# SAN FRANCISCO PLANNING DEPARTMENT

## Memo to the Planning Commission

HEARING DATE: JULY 26, 2018  
Continued from the May 24, 2018 Hearing

*Date:* July 19, 2018  
*Case No.:* 2016-015727DRP-02  
*Project Address:* **556 27th STREET**  
*Zoning:* RM-1 (Residential-Mixed, Low Density)  
40-X Height and Bulk District  
*Block/Lot:* 6581/080  
*Project Sponsor:* Handel Architects  
735 Market Street, 2<sup>nd</sup> Floor  
San Francisco, CA 94103  
*Staff Contact:* Chris Townes – (415) 575-9195  
[chris.townes@sfgov.org](mailto:chris.townes@sfgov.org)  
*Recommendation:* **Take DR and approve with modifications.**

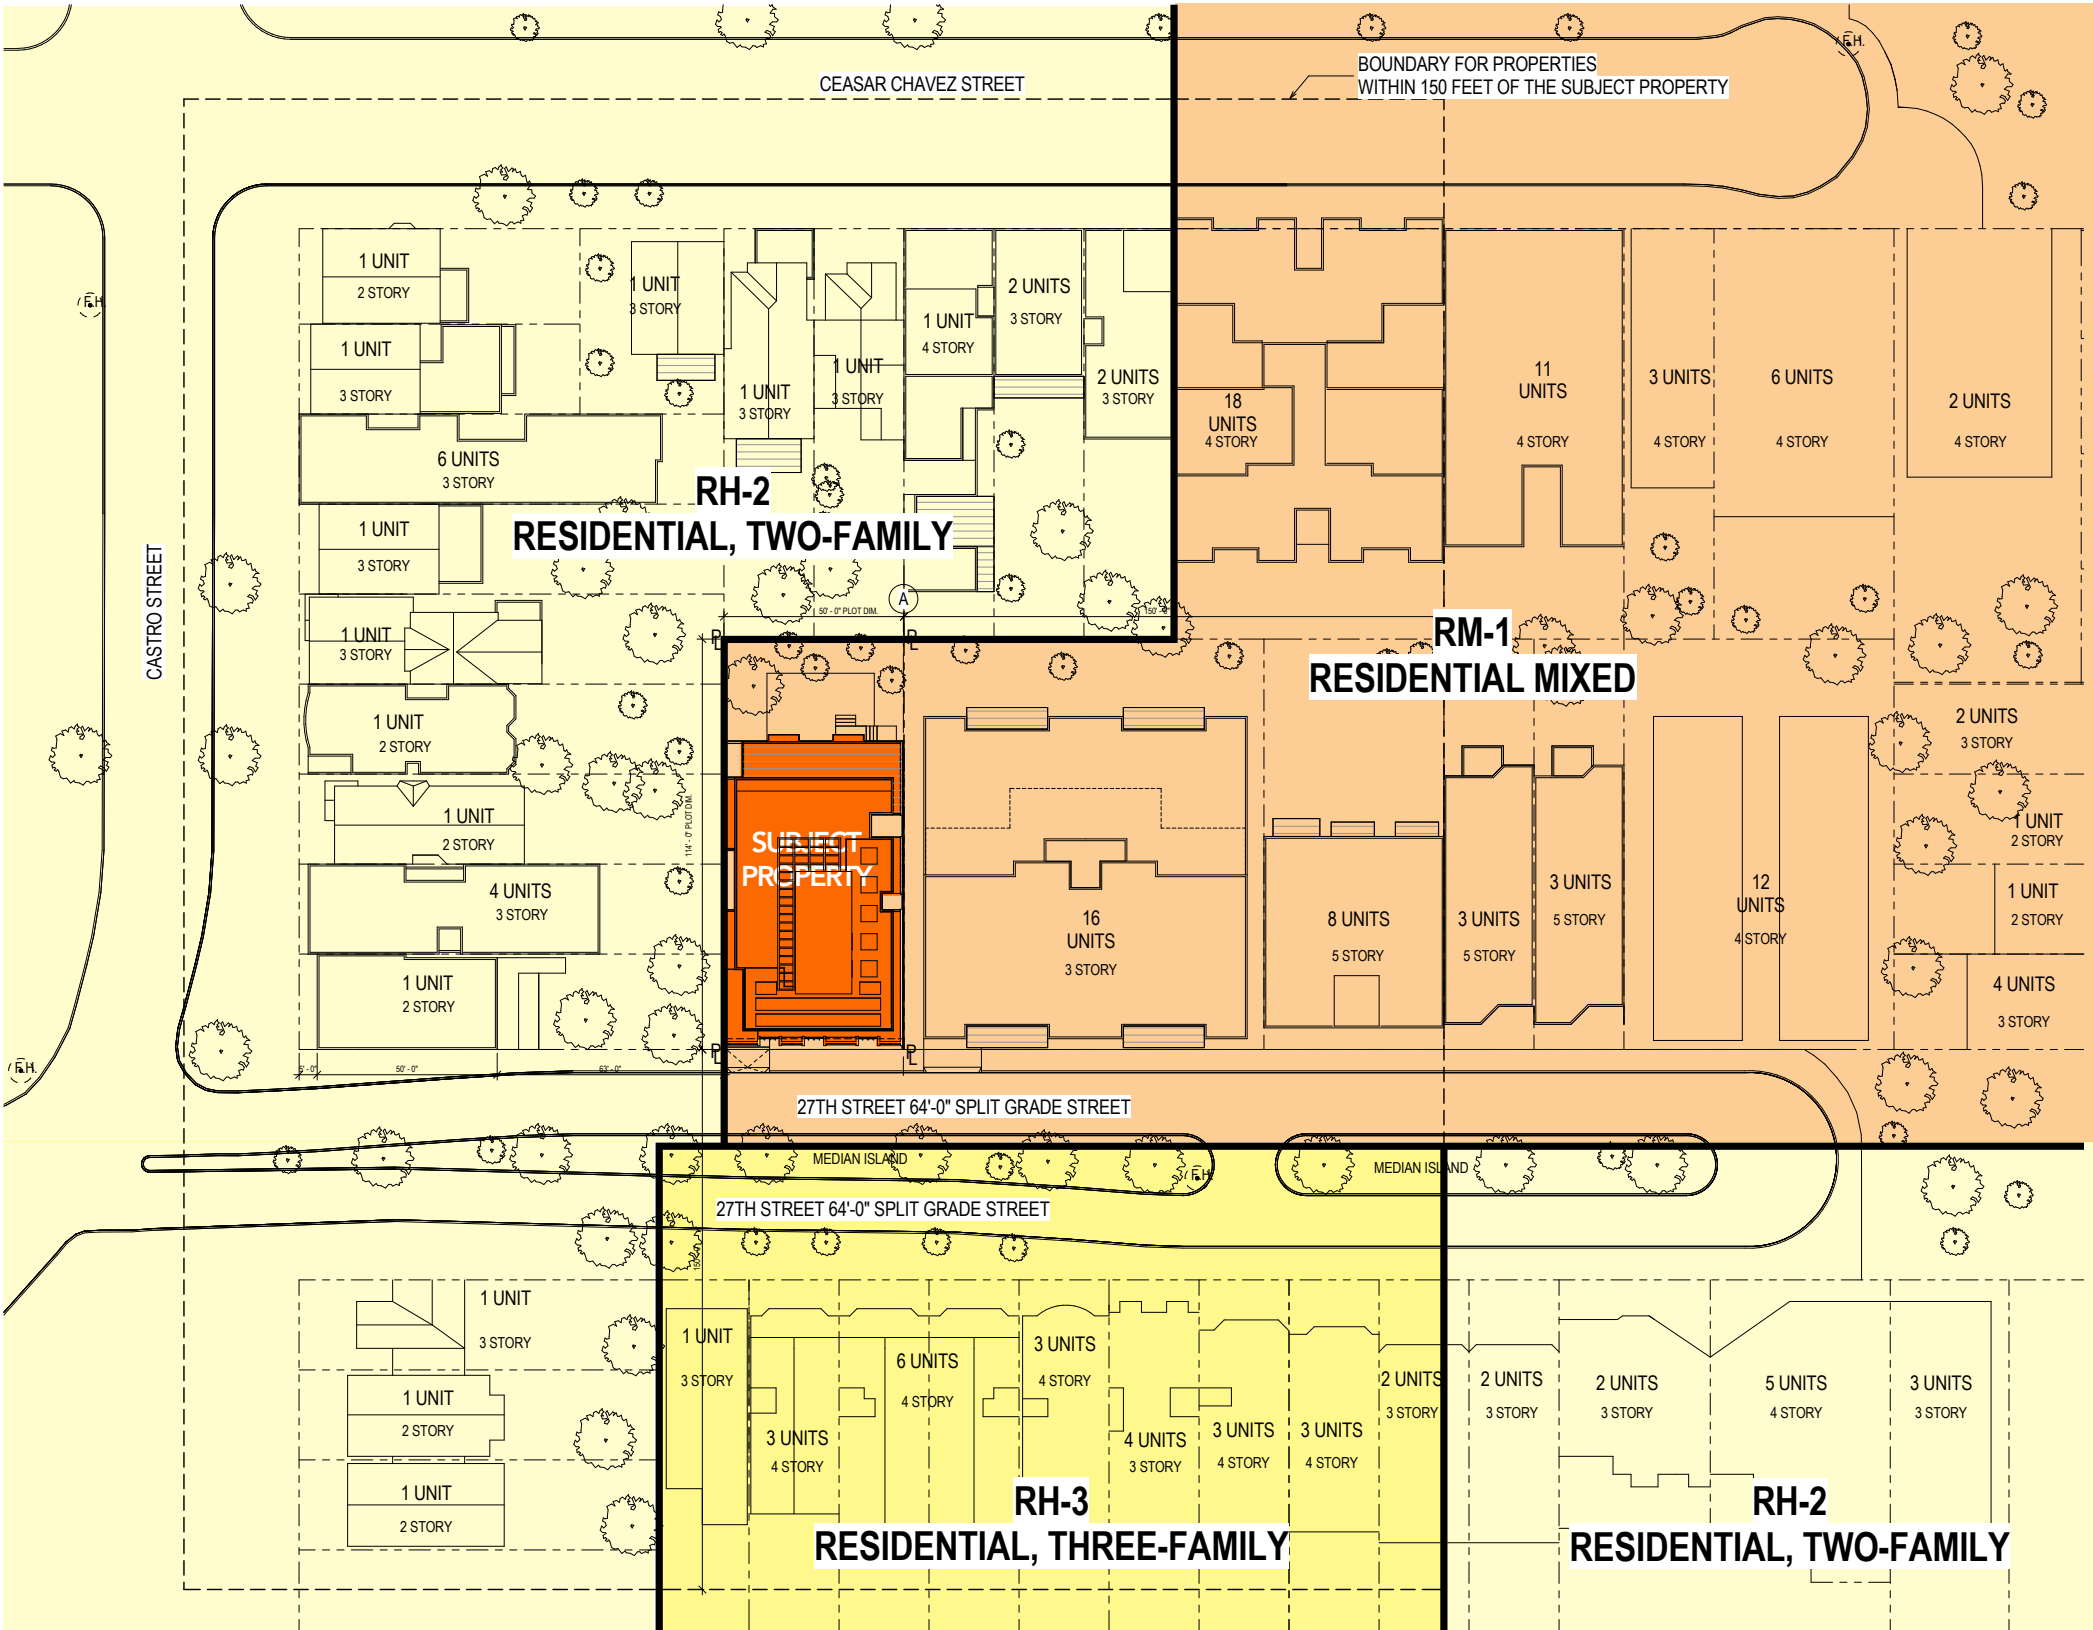
*o Significant sculpting and terracing on the western elevation that faces the rear yards of the adjacent properties on Castro Street to acknowledge this as a highly visible façade. The top floor of the rear should be setback appropriately to meet Code and provide better access to the mid-block open space. The volume above the height limit should be removed.*

**The redesign of project has incorporated a significant amount of sculpting per the RDT's request. The western facade has been greatly enhanced and will be significantly more sculpted than the characterless western wall of the existing adjacent property, 550 27th Street.**

# Proposed Scheme Prior to DR (APPROVED BY PLANNING & RDAT FOR 311 SUBMITTAL) 9/12/2017

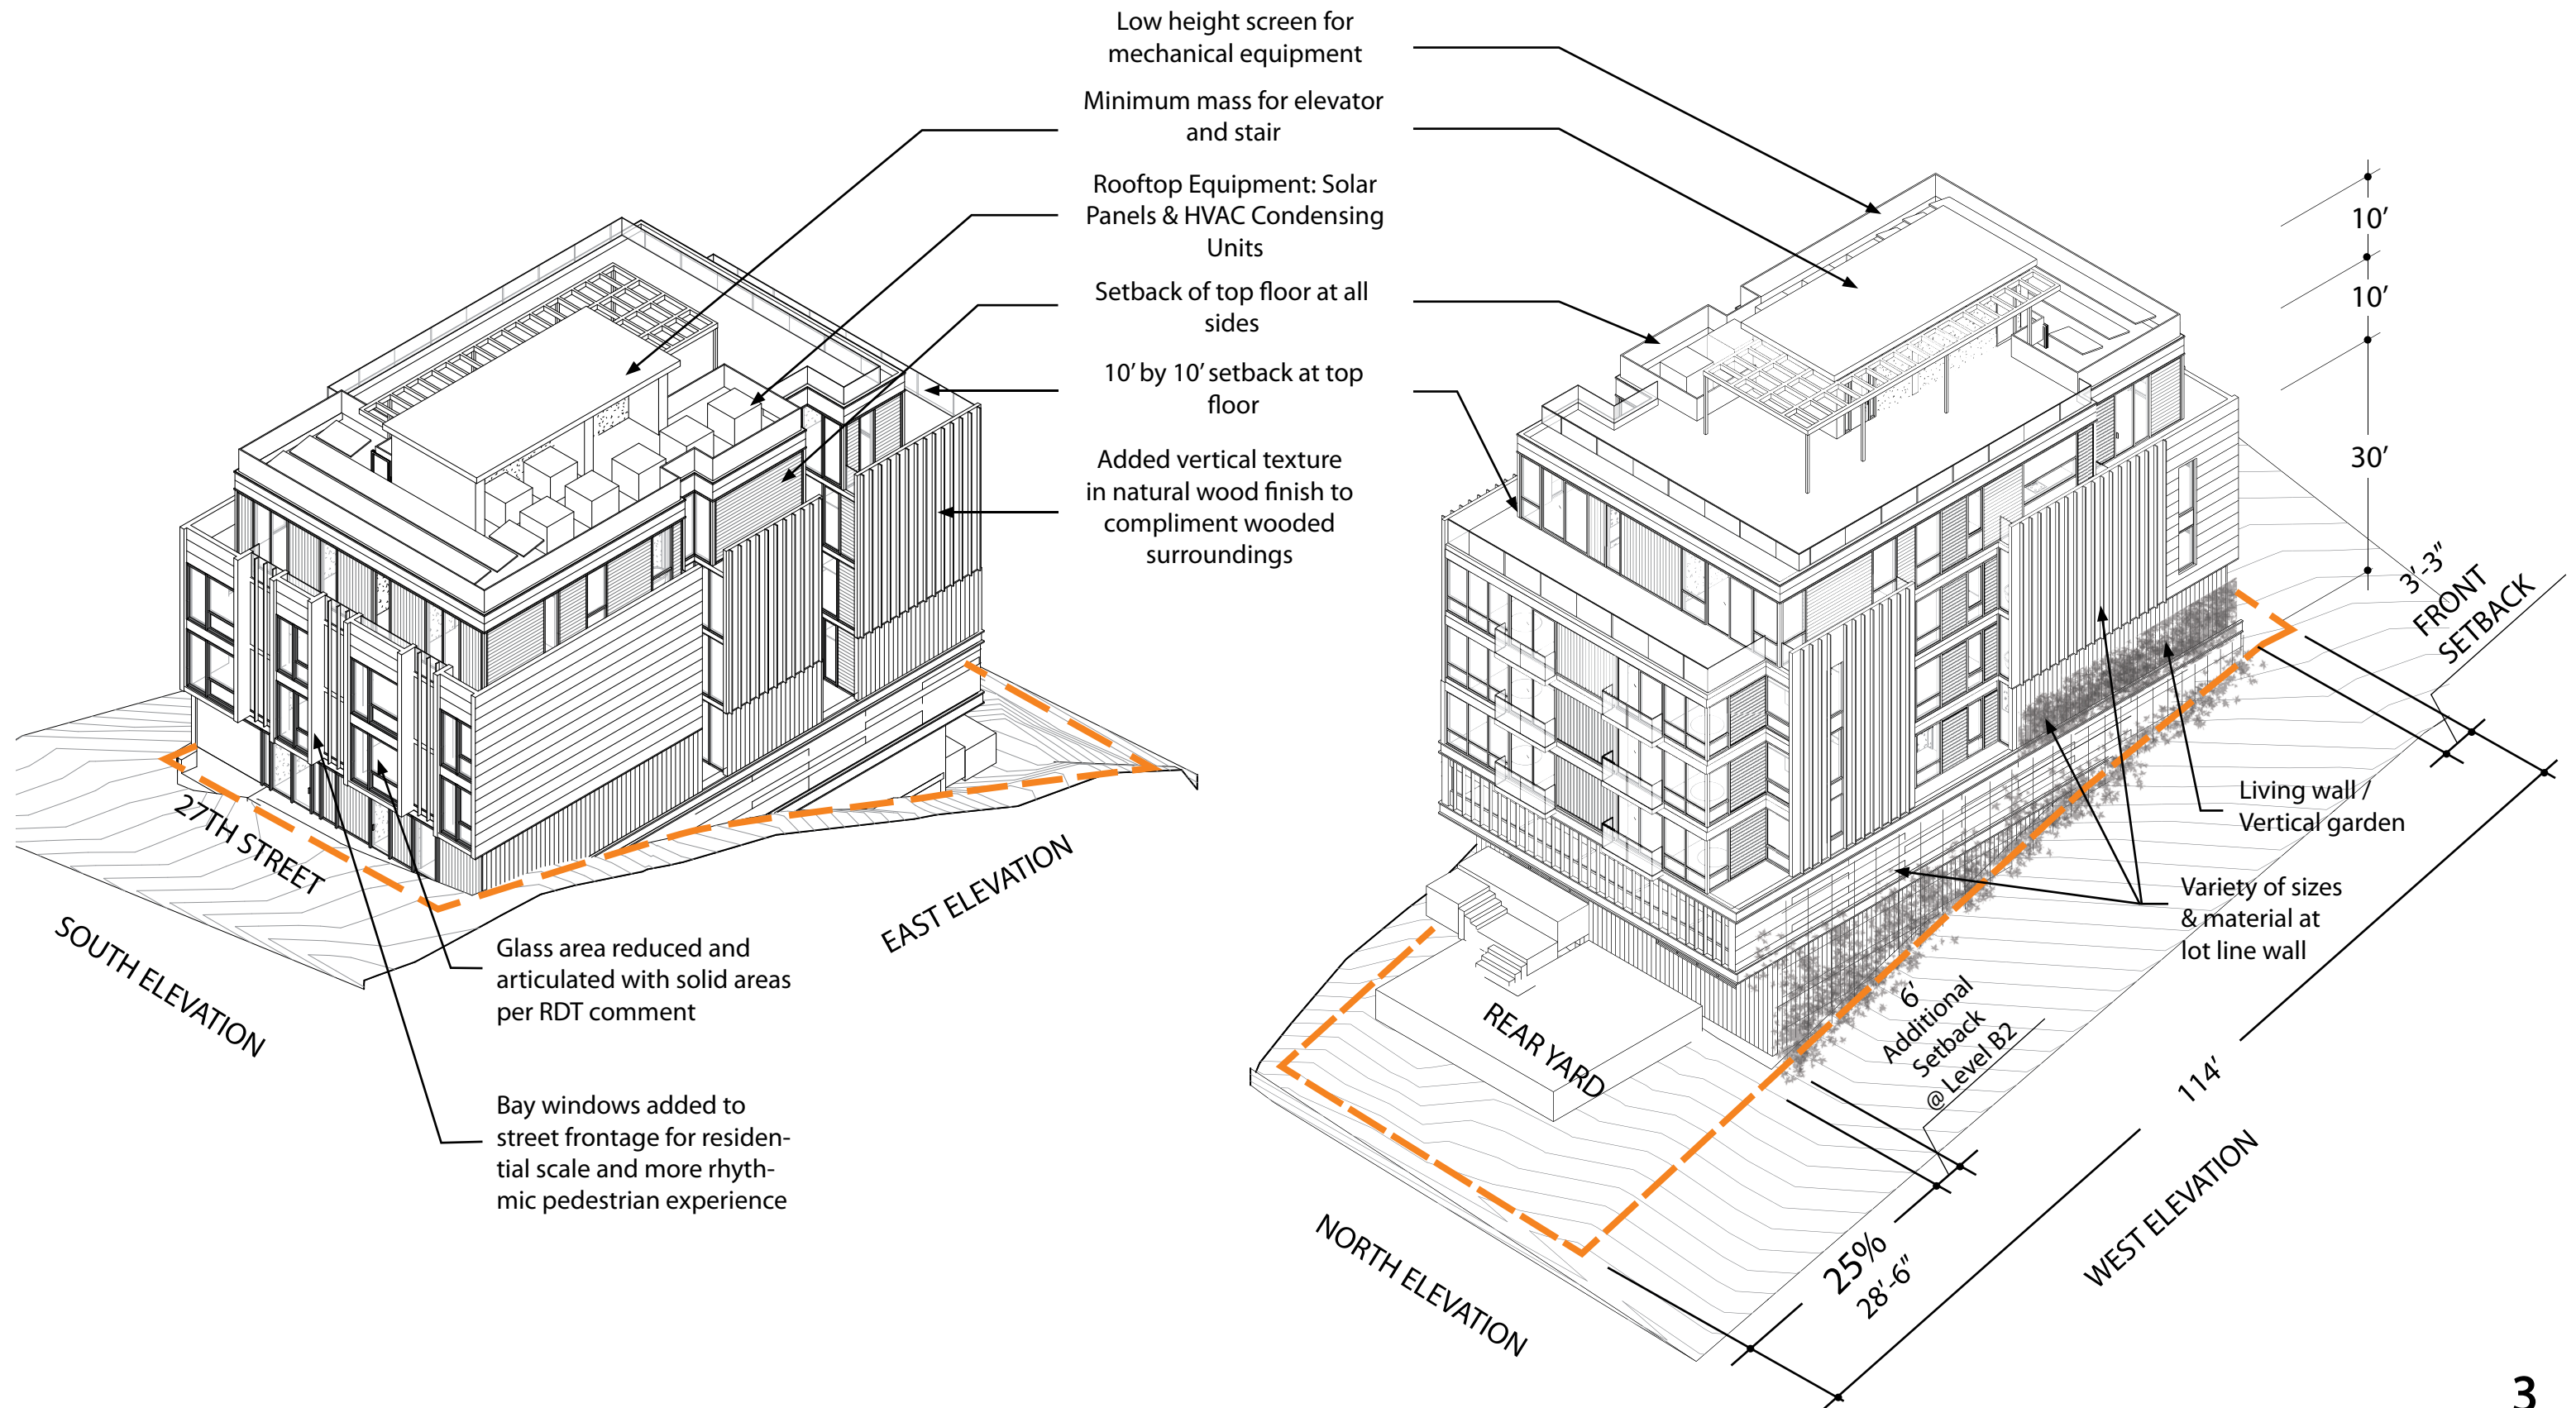
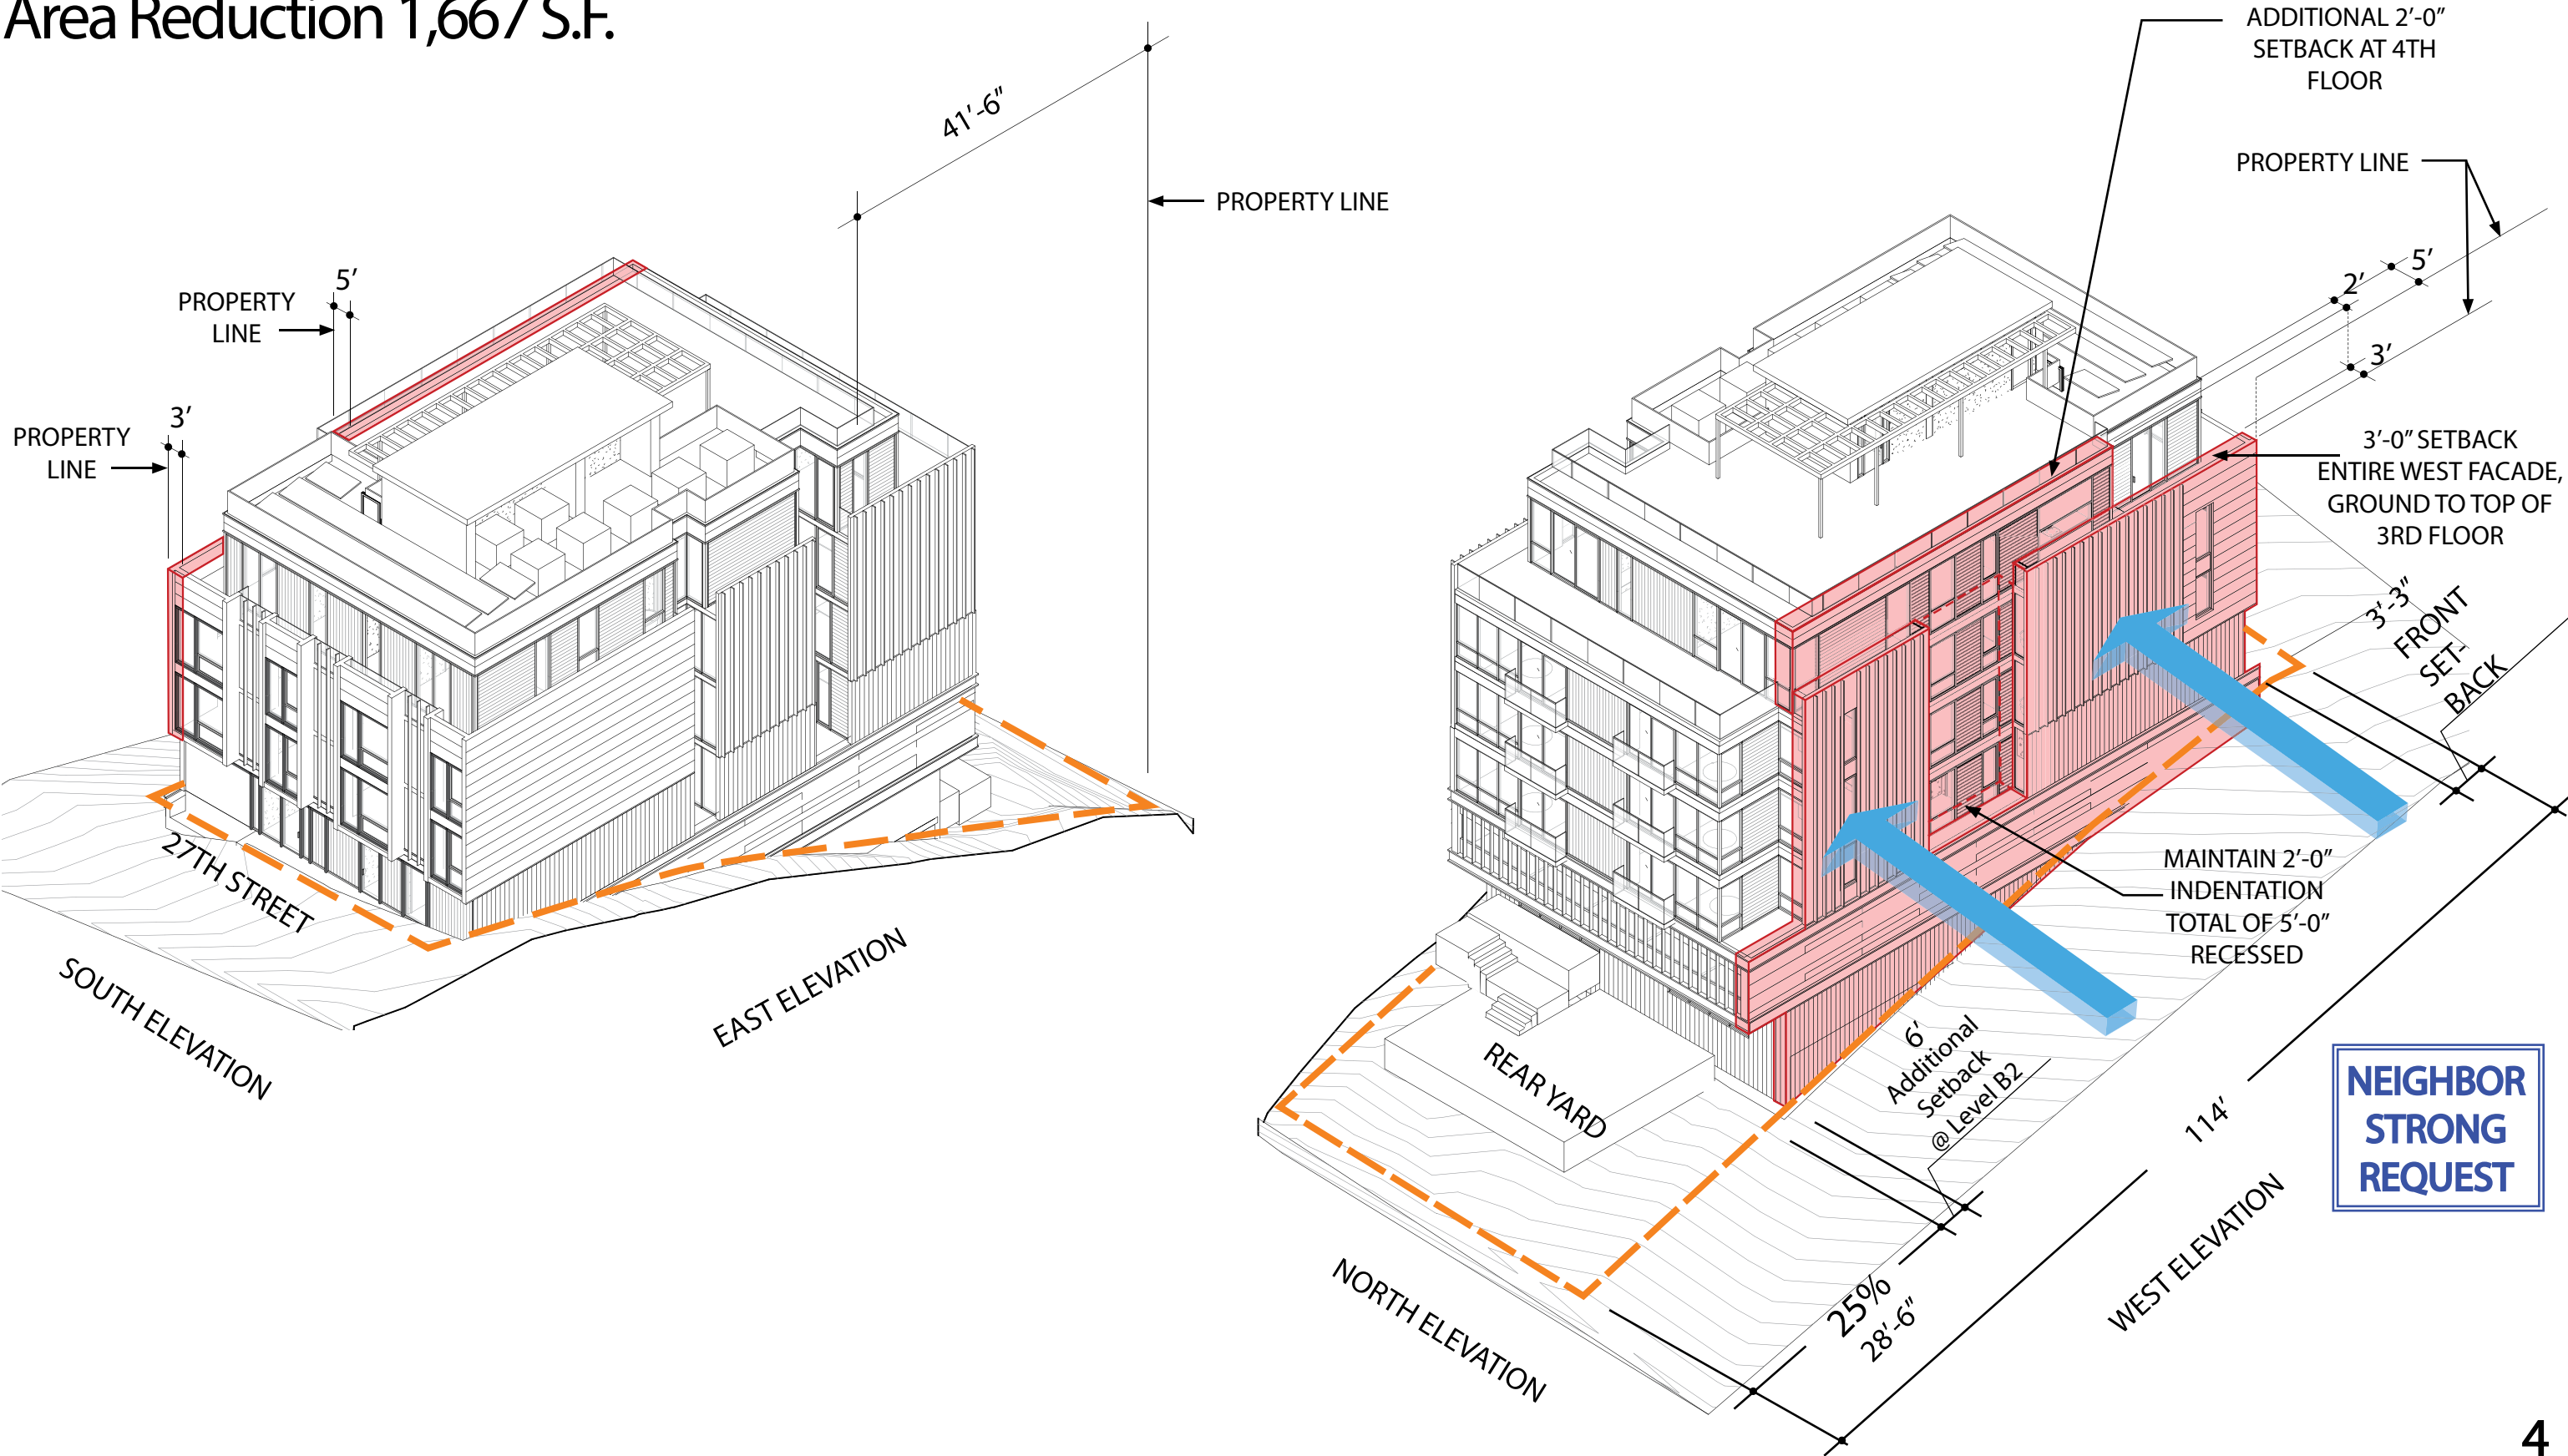
# Mitigation 2: Massing Reduction Per RDAT Comments (POST DR FILING) RECEIVED 4/24/2018

# Mitigation 3: Sponsor Proposed Resolution 5/4/2018

**PROJECT  
SPONSOR  
PROPOSED  
RESOLUTION**
